10.24.2022
Correspondence,
Updated WBD,
FSP analysis

From: Nathan Alleman <nalleman@all-llc.com>
Sent: Monday, October 24, 2022 8:33 AM
To: Rose-Coss, Dylan, EMNRD
Cc: Oliver Seekins; Devin Bowes; Cody Pardue
Subject: [EXTERNAL] RE: Rev Midstream - AABCD SWD #1 & #2 Supplemental Information
Attachments: AABCD SWD #1 WBD 09202022.pdf; AABCD SWD #1 - Revised Injection Interval - Supplemental Information.pdf; AABCD SWD #2 WBD 09202022.pdf; AABCD SWD #2 - Revised Injection Interval - Supplemental Information.pdf; REV Midstream - AABCD FSPs.pdf

Well Name: AABCD SWD #1

REV Midstream LLC AABCD SWDs #1 & #2 FSP

AAABCD SWD #1
Wellbore Diagram
965' FEL & 983' FNL S-35 T-21S R-27E
Lat: 32.44109° Long: -104.154831°
Eddy County, New Mexico

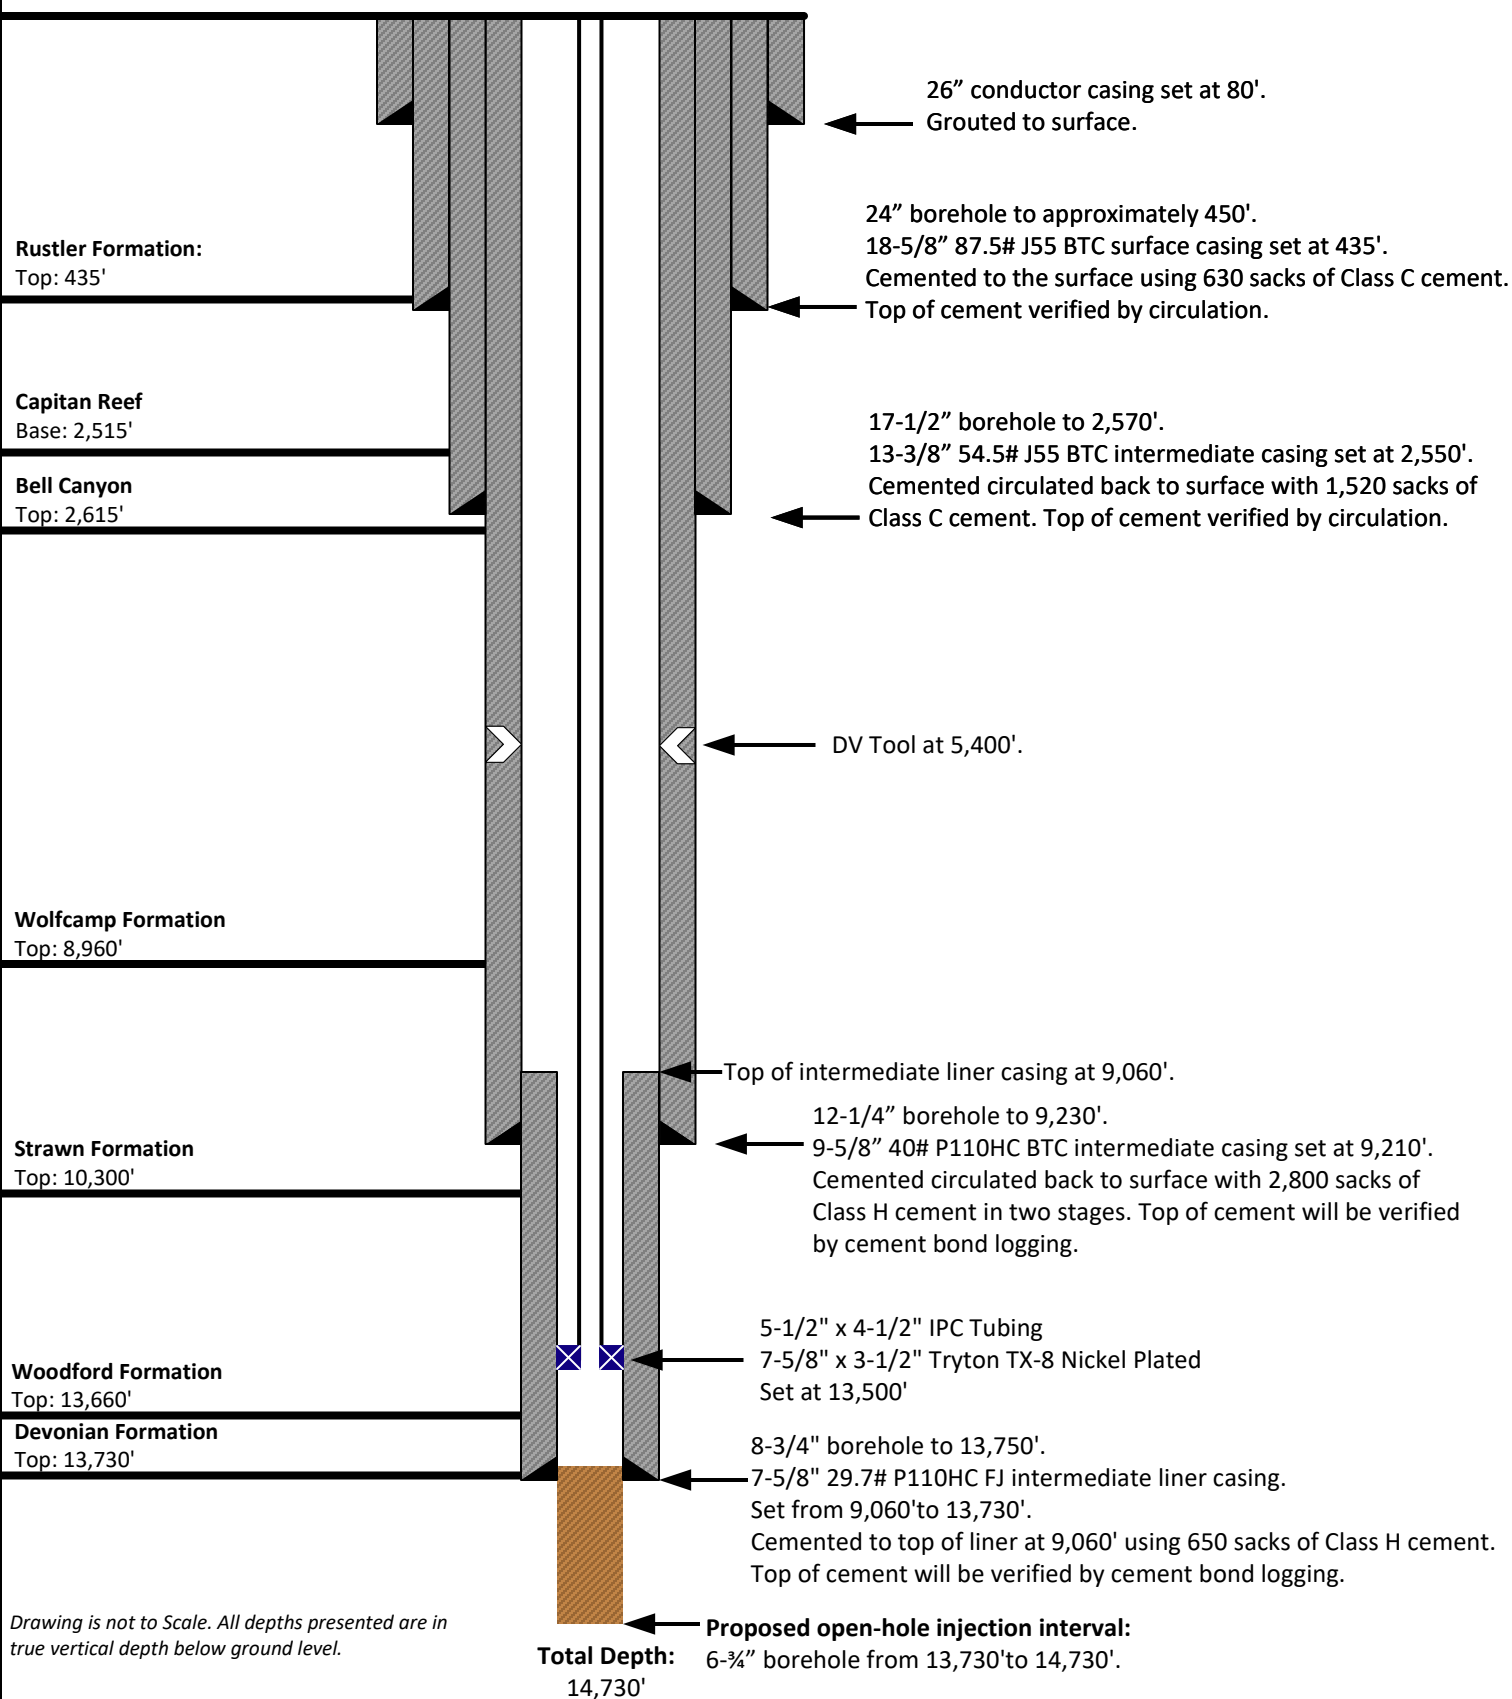
1. [OCD Request: Please confirm the method of determining the top cement for the 7" production casing string. The injection well data sheet indicates that the cement will be circulated to the surface, but the wellbore diagram suggests that the top will be at 9500'. The OCD requests that the 7" production string tie in 200' above the intermediate casing.](#)

- **Response:** The well design has been updated to clarify cement tops and methods of determination (see attached Supplemental Information and Wellbore Diagrams). Additionally, the well designs were updated to reflect corrected depths for the Devonian Injection Interval. Wellbore Diagrams and Well Data Sheets reflecting the updated well designs are attached.

AABCD #1 FSP Area Map

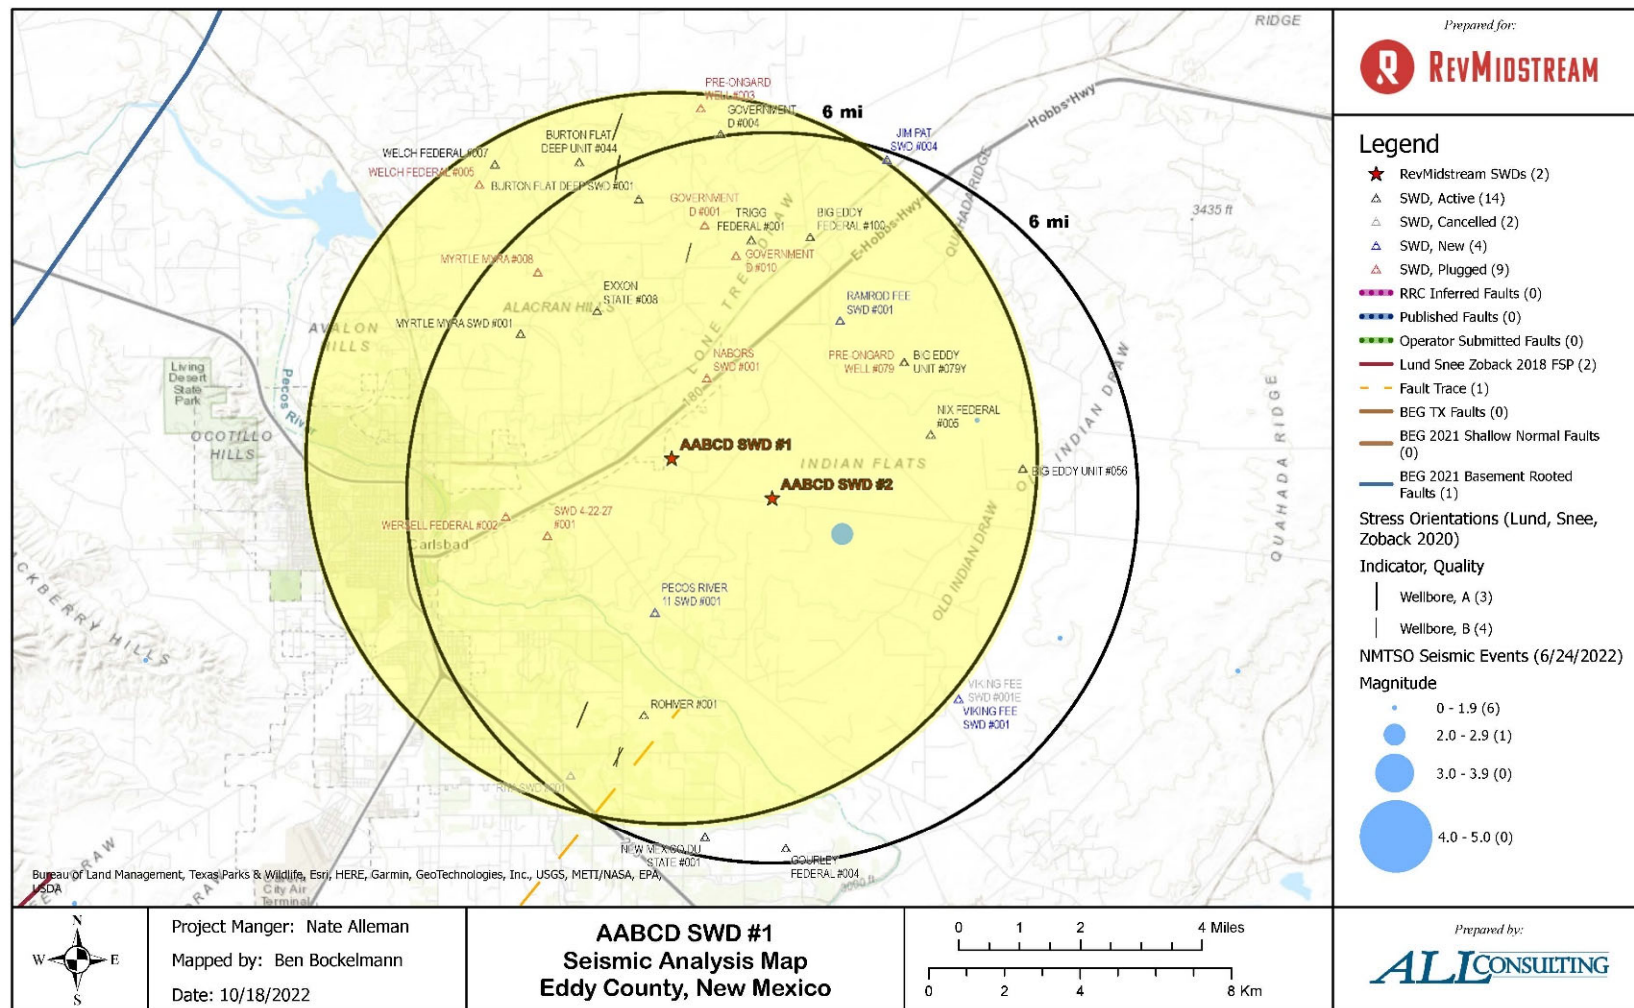
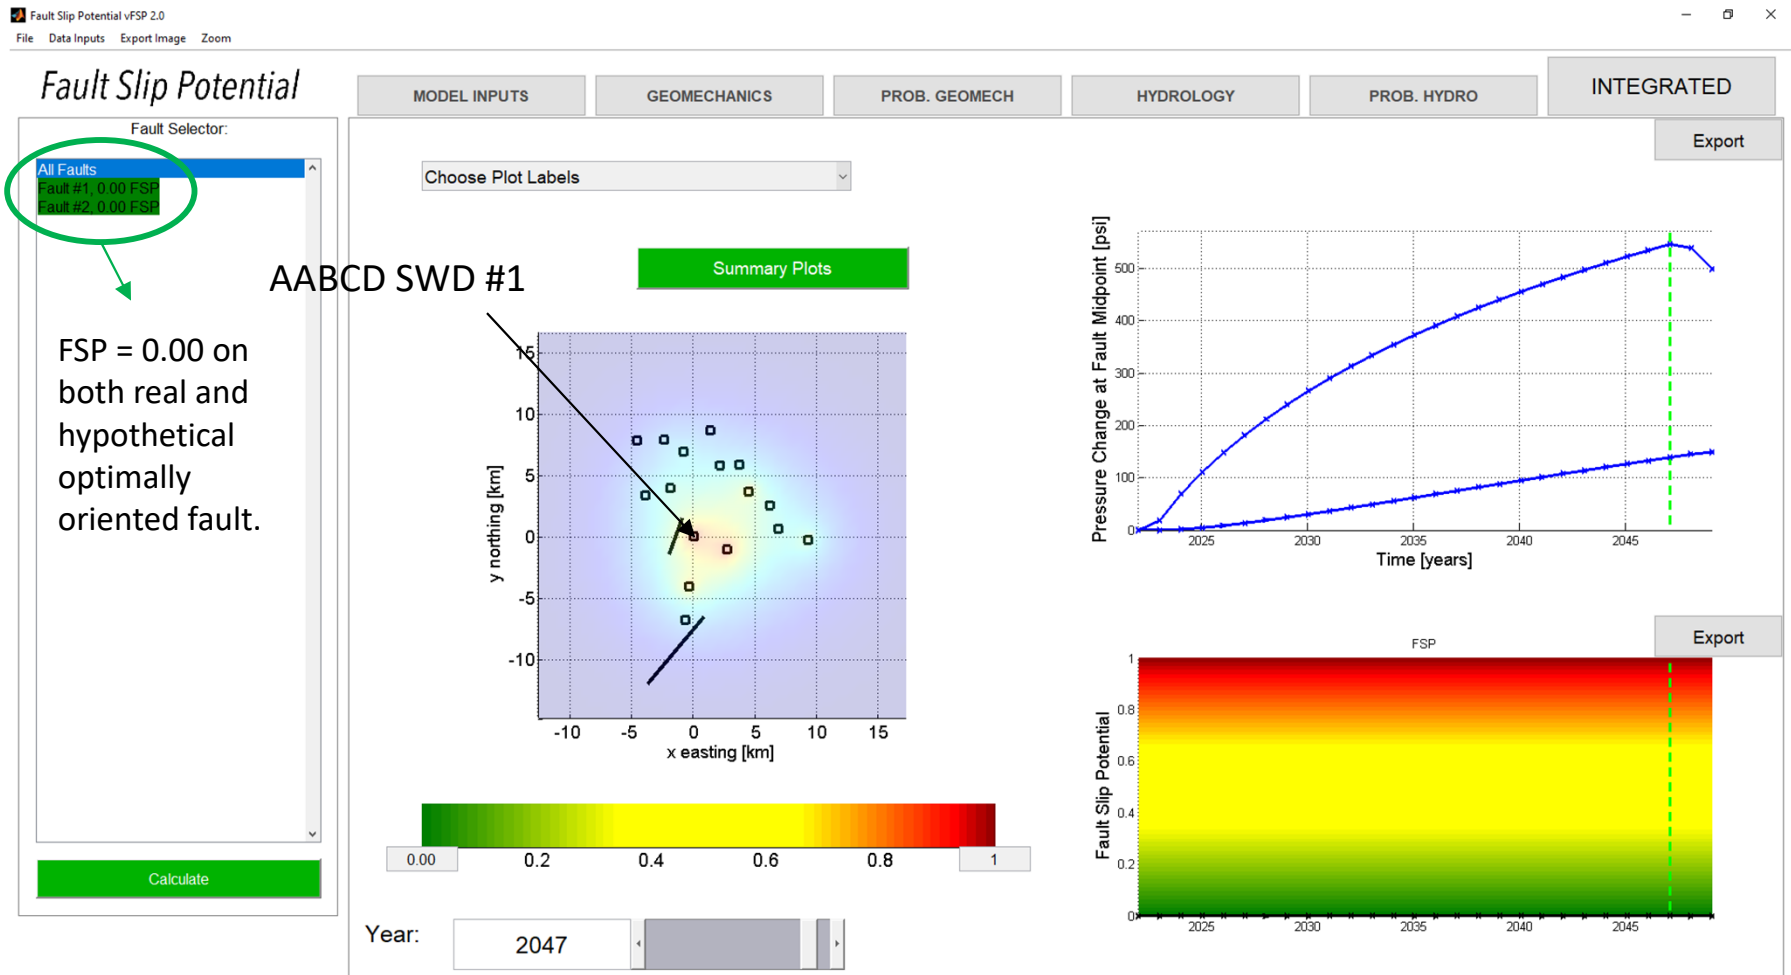
3. [OCD Request: Submit a fault slip potential \(FSP\) model to supplement the induced seismicity analysis.](#)
 - a. [I would refer you to case no 20964 re: Overflow Energy's Rita SWD # 1 application. In the case files nearby fault traces are identified that should be incorporated into the model.](#)

- b. [Include a model run scenario that incorporates a fault trace within one \(1\) mile of the proposed well that is optimally oriented to slip.](#)
 - **Response:** FSP models were run for the AABCD SWD #1 and #2 using the criteria specified above and the models resulted in a 0.00 FSP value on both the known and hypothetical faults.

- One known fault exists in the 6-mile radius area of review. One hypothetical optimally oriented fault added to each model run per NMOCD request.
- FSP modeling through 25 years, with injection rates that are likely overestimated, show no risk of potential fault slip in the area on hypothetical optimally oriented fault.
- Known fault within the area of review is not optimally oriented for slip and shows no risk of potential fault slip.
- This area presents little to no risk for injection induced seismicity.
